UNITED STATES PATENT AND TRADEMARK OFFICE

| APPLICATION NO. | FILING DATE | FIRST NAMED INVENTOR | ATTORNEY DOCKET NO. | CONFIRMATION NO. |
|-----------------|-------------|----------------------|-----------------------|------------------|
| 10/804,488 | 03/19/2004 | Jeffrey L. Tonges | 2003-0808.00/4670-261 | 7635 |

| Office Action Summary | Application No. 10/804,488 | Applicant(s) TONGES ET AL.  | |

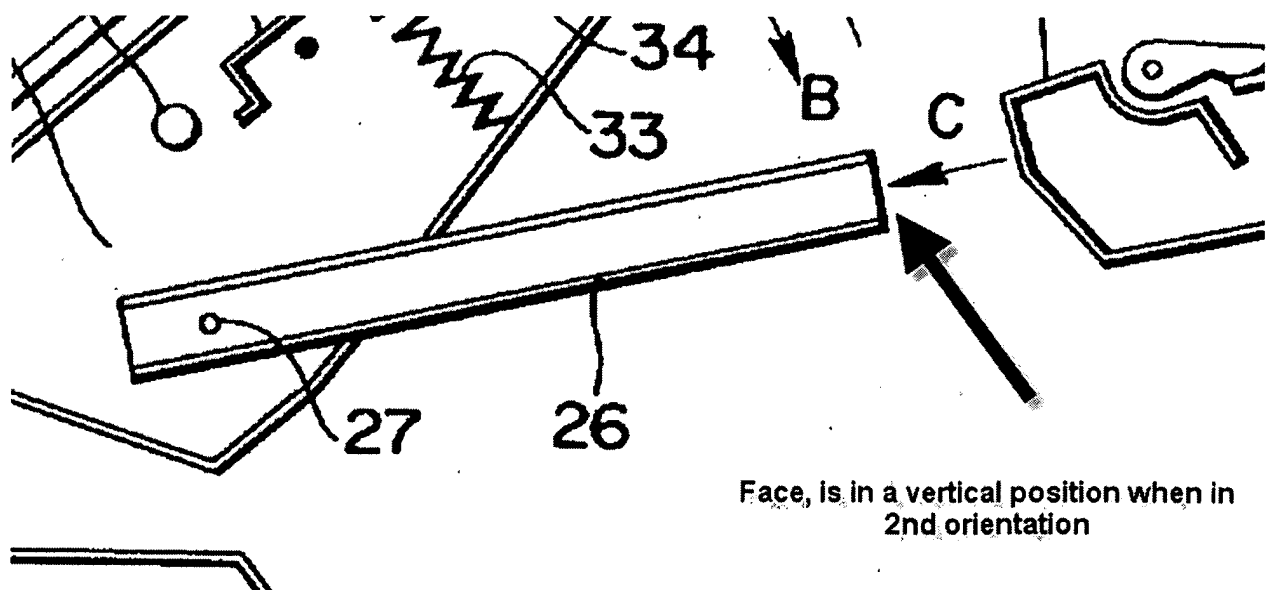
Regarding claim 14, Takahashi teaches, "An image forming device comprising: a body (1); a developer member (10) positioned within the body; a first frame (22) having a first end (Fig. 2, near ref.# 22) and a second end (Fig. 2, near ref.# 21); a first pivot (24) adjacent to the first end that connects the first frame to the body, the first frame being relatively positionable between a first orientation with the second end distanced from the body (open, as shown in Fig. 2), and a second orientation with the second end in proximity to the body (closed, as shown in Fig. 1); a second frame (26, 29 and 6 in combination) having a photoconductive member; and a second pivot (27) that connects the second frame to the first frame and causing the second frame to pivot separately

Regarding claim 15, Takahashi teaches, “wherein the second end contacts the body in the second orientation (22 contacts 23 when in 2nd orientation).”

Regarding claim 16, Takahashi teaches, “wherein the first pivot is located vertically below the second pivot when the first frame is in the second orientation (24 is vertically below 27 when in 2nd orientation).”

Regarding claim 18, Takahashi teaches, “wherein the second frame comprises a face opposite from a connection with the second pivot, the face being substantially vertical in the second orientation (part of 26 ‘face’ is vertical in Fig. 1 when in 2nd orientation, see below).”
